Report to the Future Melbourne (Planning) Committee

**Ministerial Planning Referral: TPMR-2016-23/A
681-693 Collins Street, Docklands
Melbourne Quarter Tower (Stage C2)**

16 April 2019

| Proposal: | Proposal to amend Planning Permit PA1600147 and associated plans in relation to a revised Melbourne Quarter Tower (Stage C2) development proposal. |

Sheet title
**Shadow Diagrams
 Winter Solstice & Spring Equinox
 Shadow Diagrams**

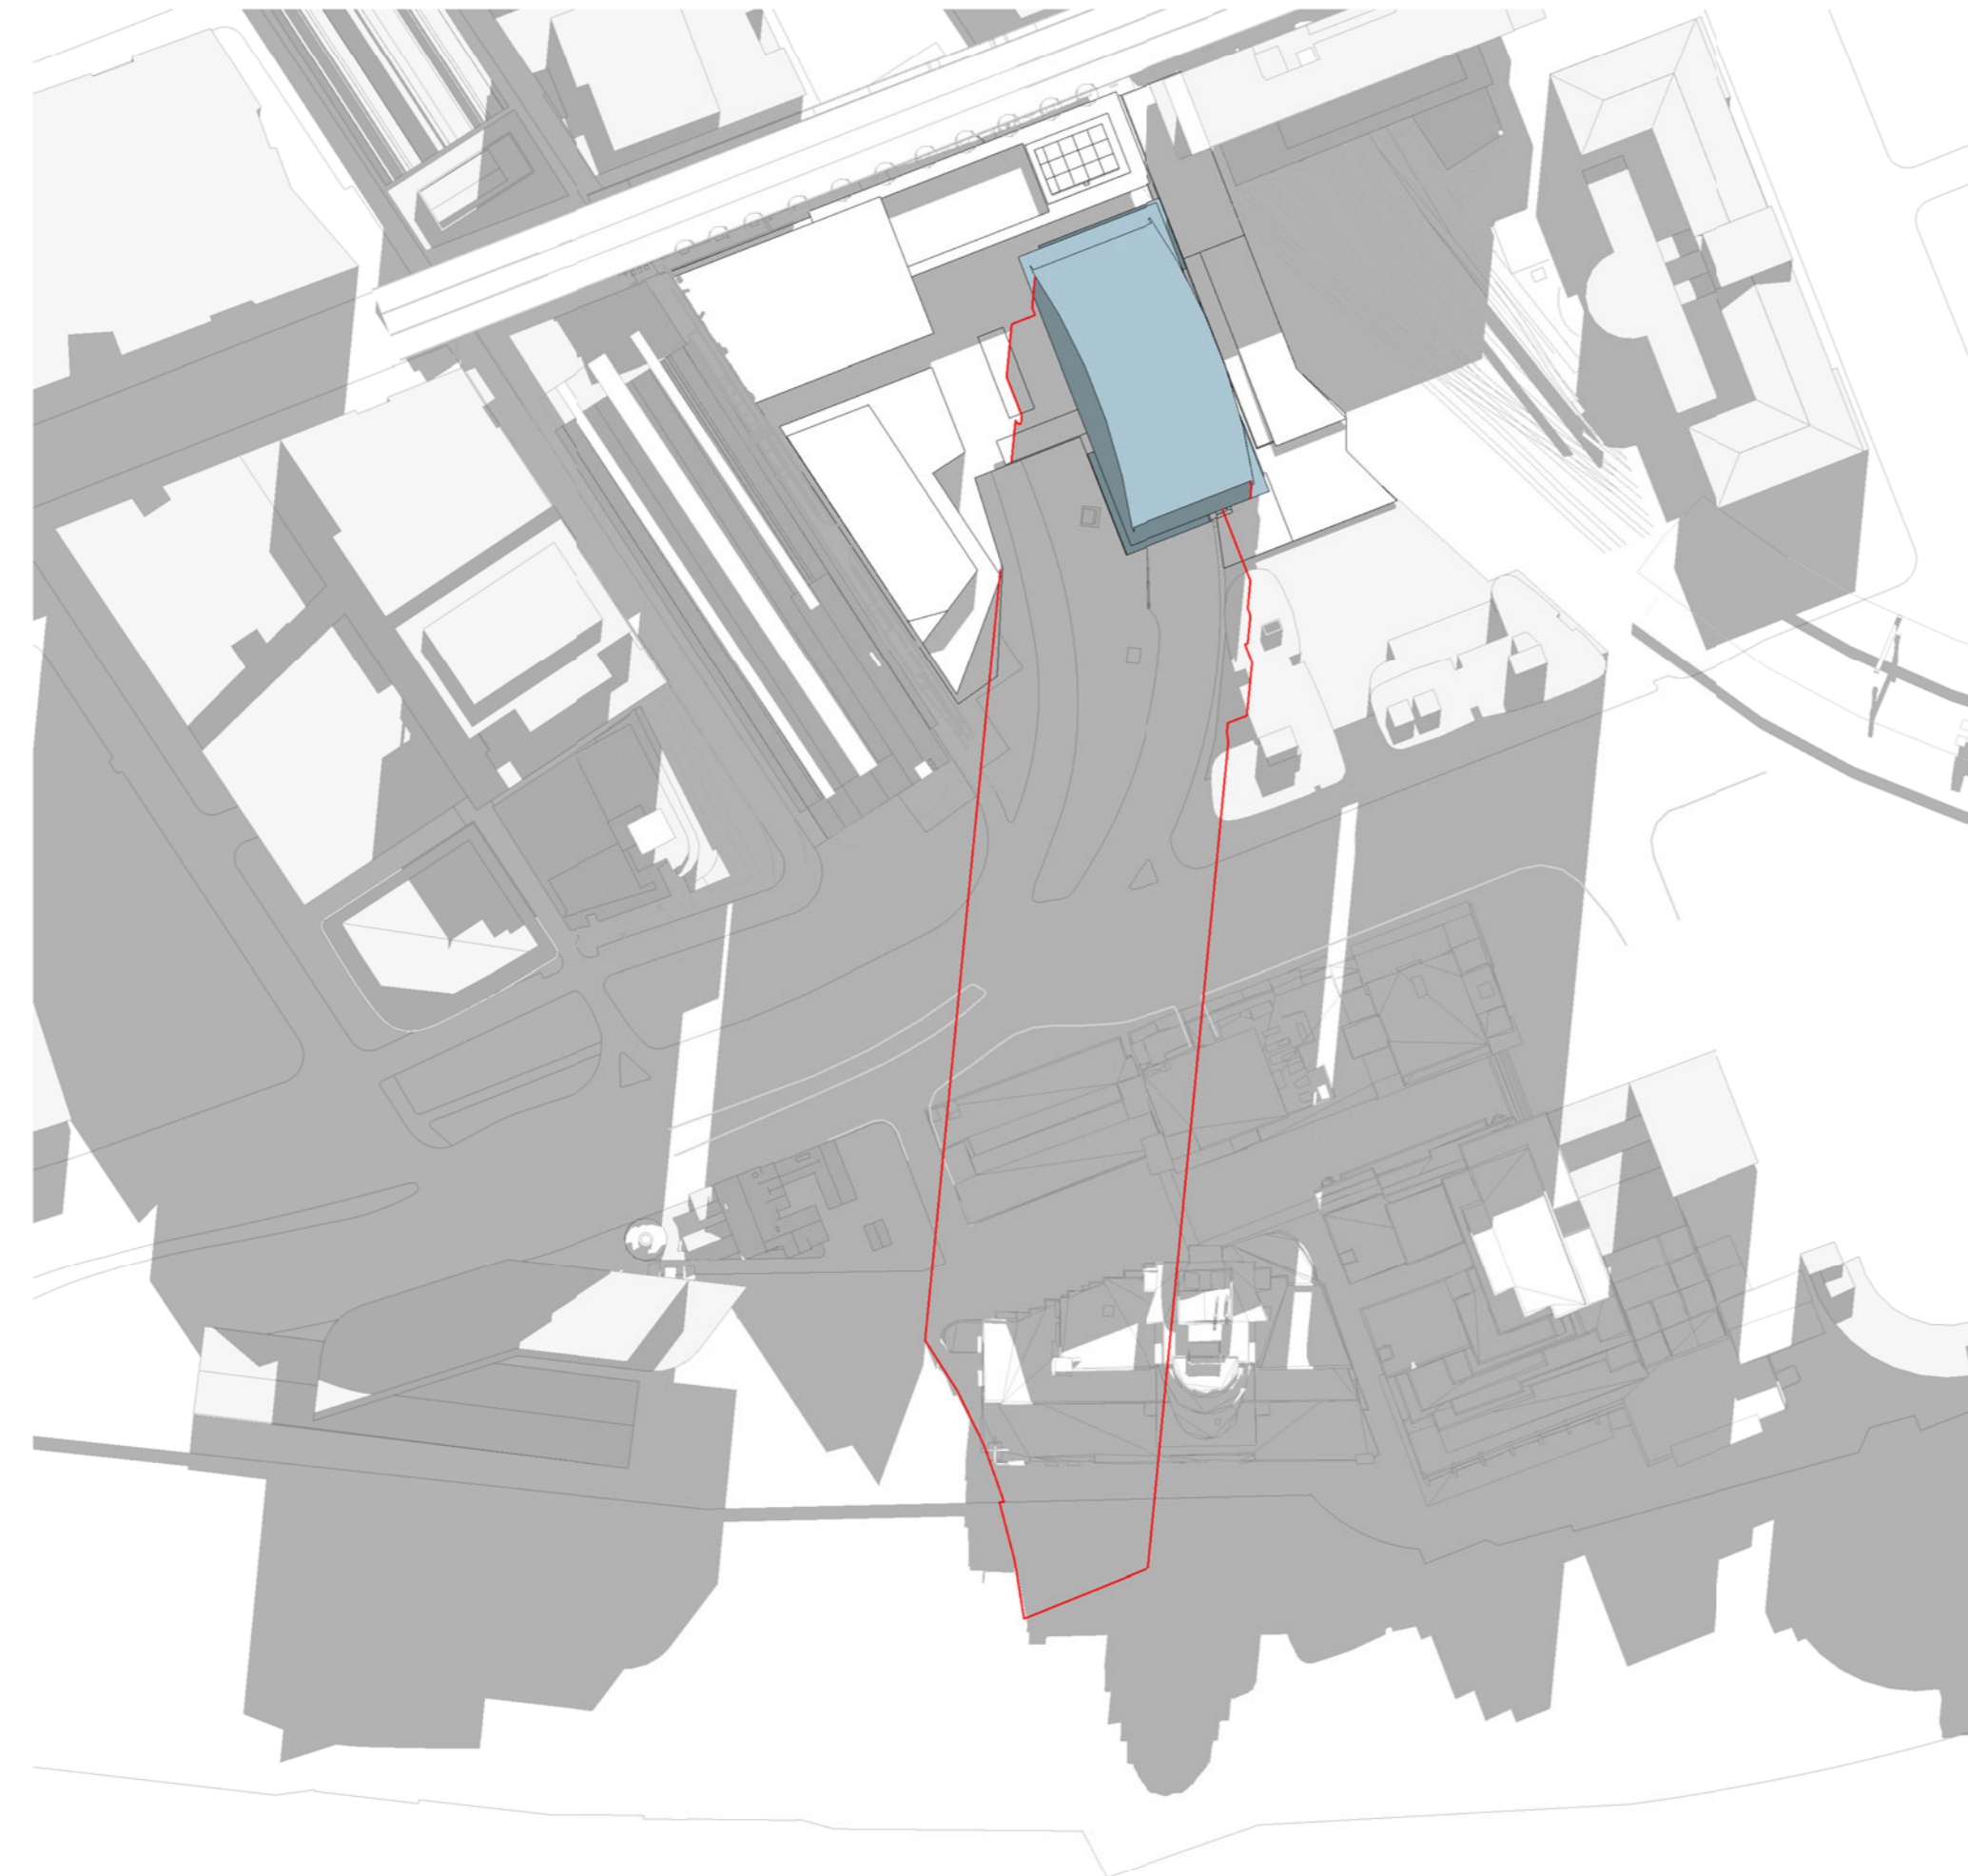
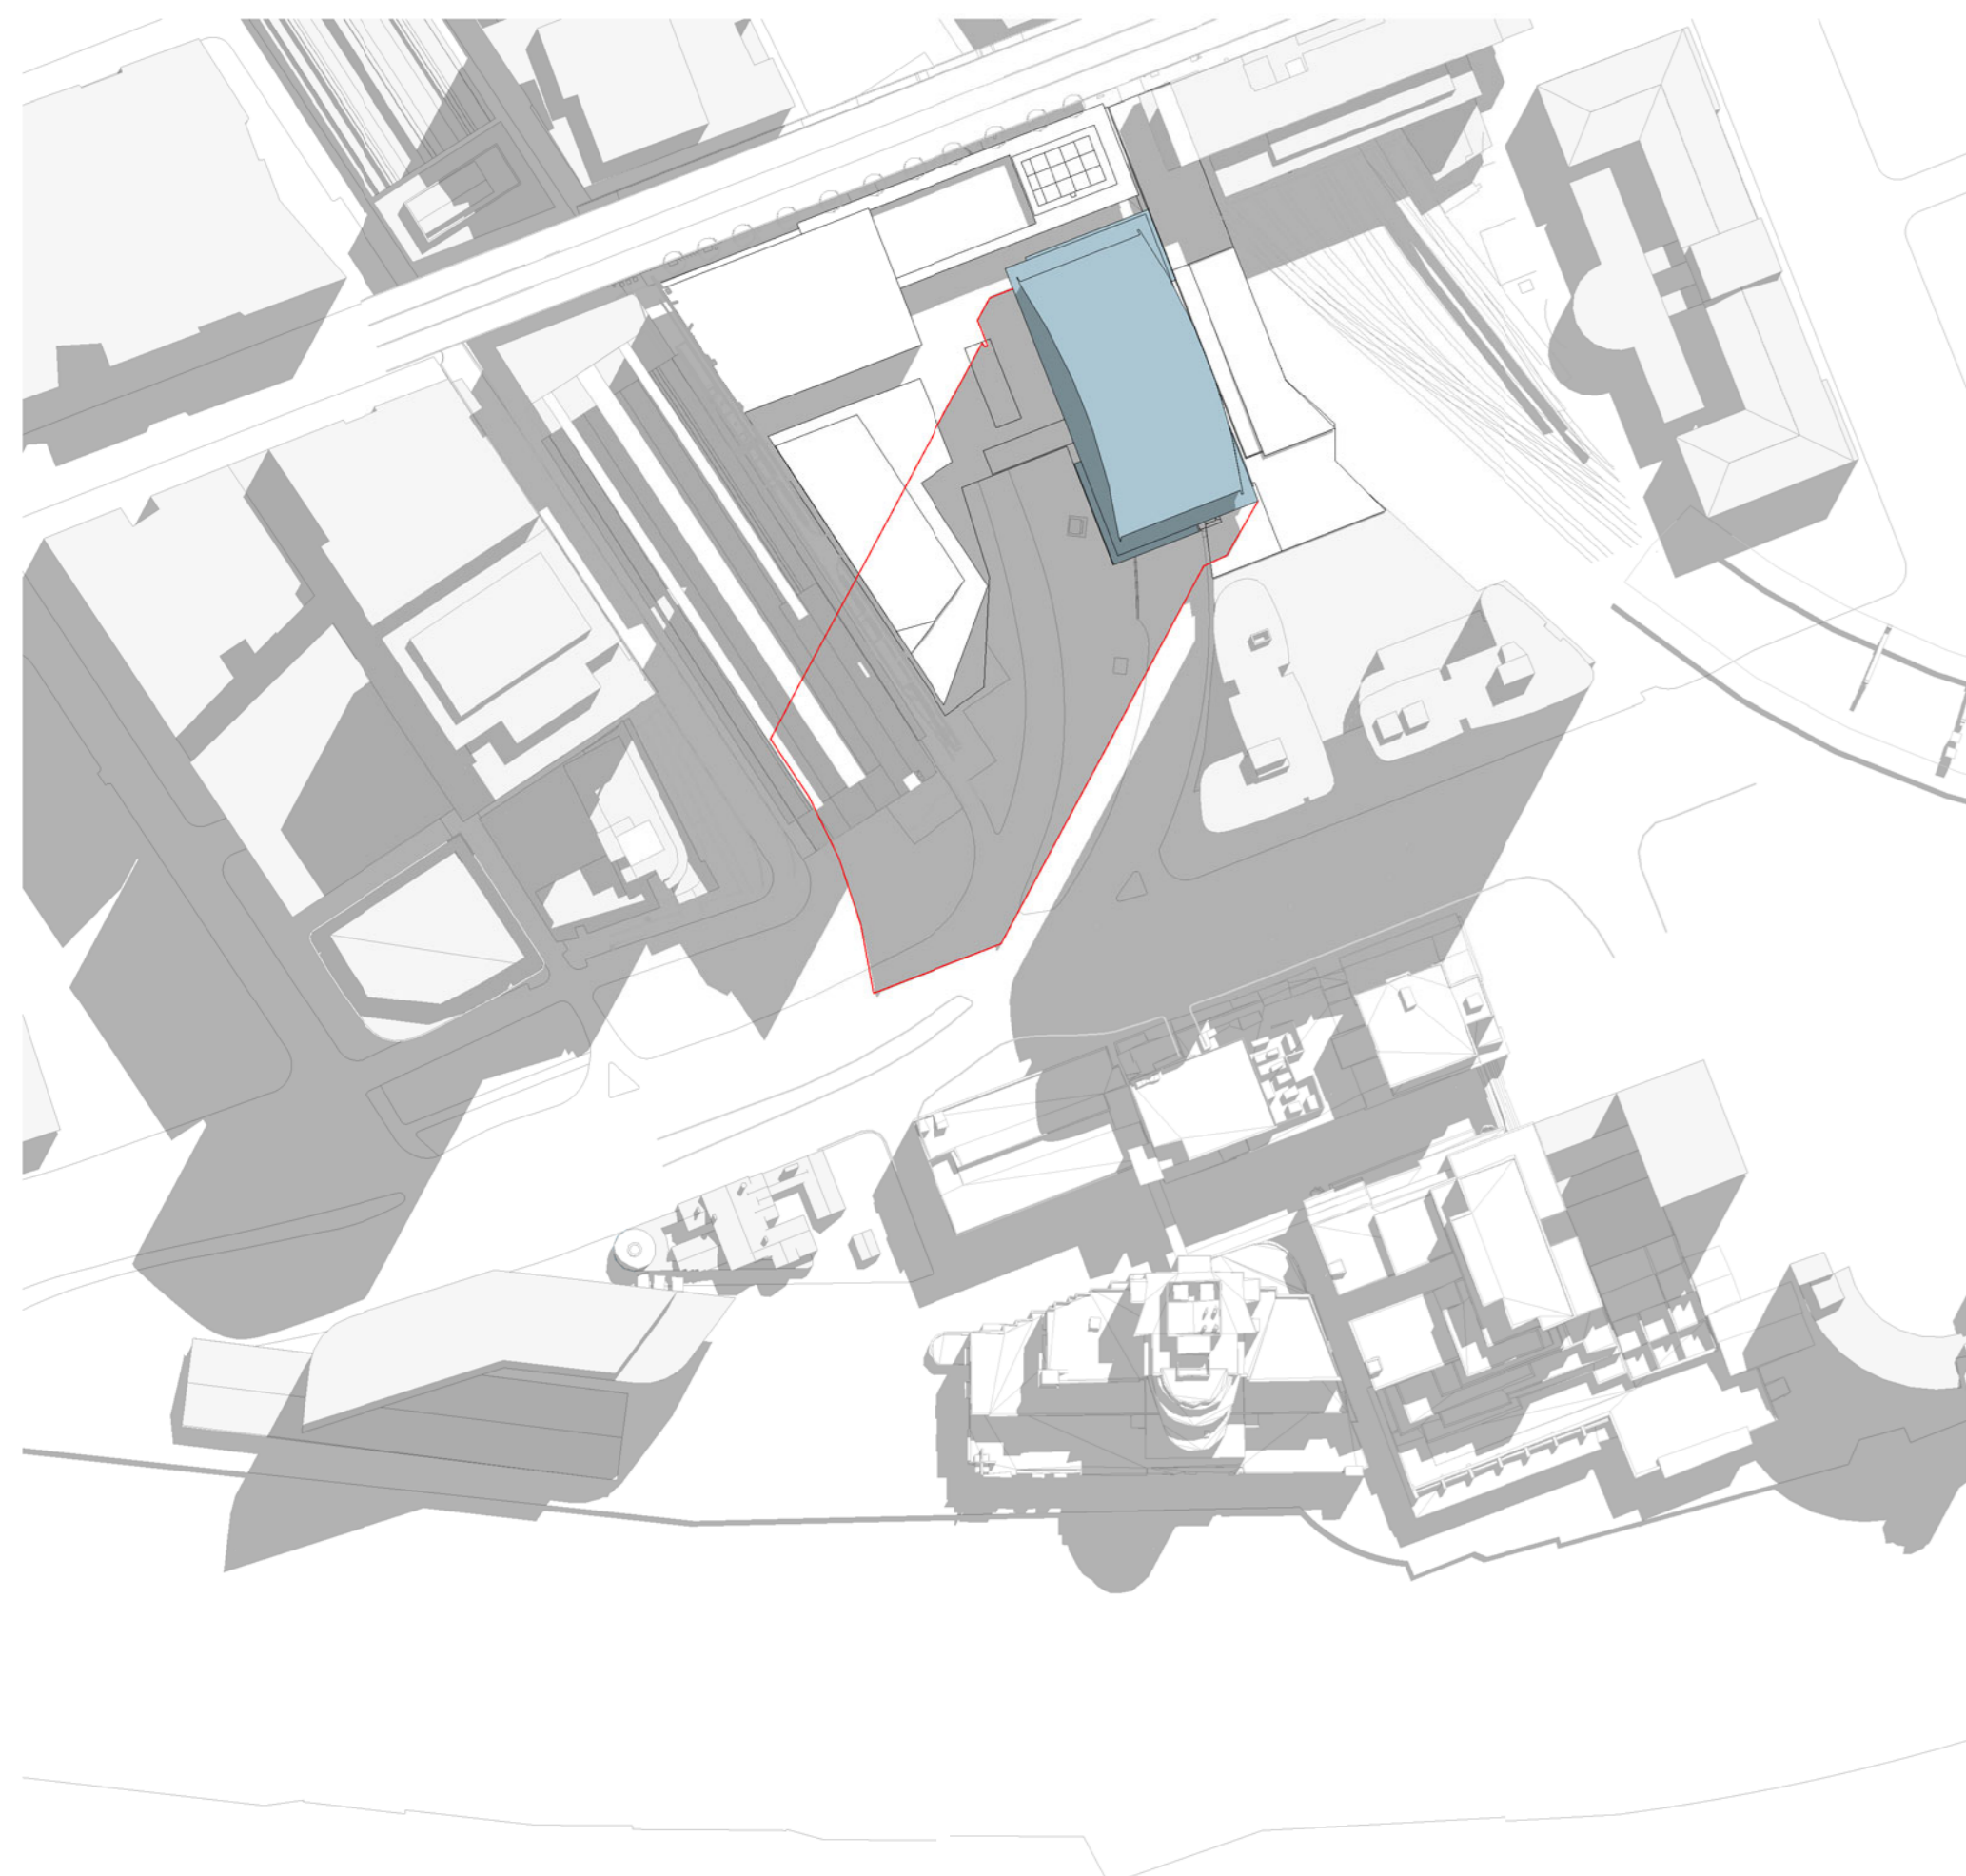
9. The overshadowing is compliant with the requirements of the development plan. Equally, wind impacts are considered to be appropriate and consistent with the development plan.
